Mobile Intel[®] Pentium[®] 4 Processor-M

Specification Update

December 2004

Document Number: **250721-028**

Figure 13. System Bus Reset and Configuration Timings

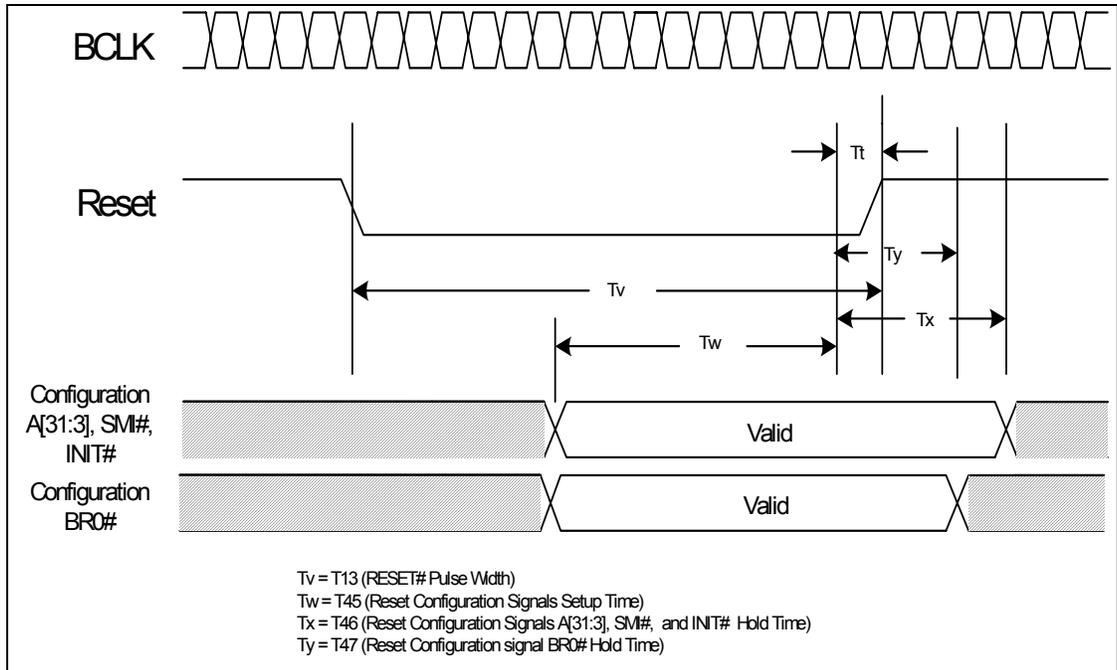
T2. BR0# Maximum Hold Time Specification Change

The BR0# maximum hold time has changed to 2 BCLKs. This change will be shown in the “System Bus AC Specifications (Reset Conditions)” table and “System Bus Reset and Configuration Timings” figure of the *Mobile Intel® Pentium® 4 Processor - M Datasheet*. This change will be incorporated in the next revision of the datasheet.

The following figure will be modified to reflect this change:

T# Parameter	Min	Max	Unit	Figure	Notes
T45: Reset Configuration Signals (A[31:3]#, BR0# INIT#, SMI#) Setup Time	4		BCLKs	13	1
T46: Reset Configuration Signals (A[31:3]#, INIT#, SMI#) Hold Time	2	20	BCLKs	13	2
T47: Reset Configuration Signal BR0# Hold Time	2	2	BCLKs	13	2

1. Before the deassertion of RESET#.
2. After clock that deasserts RESET#.
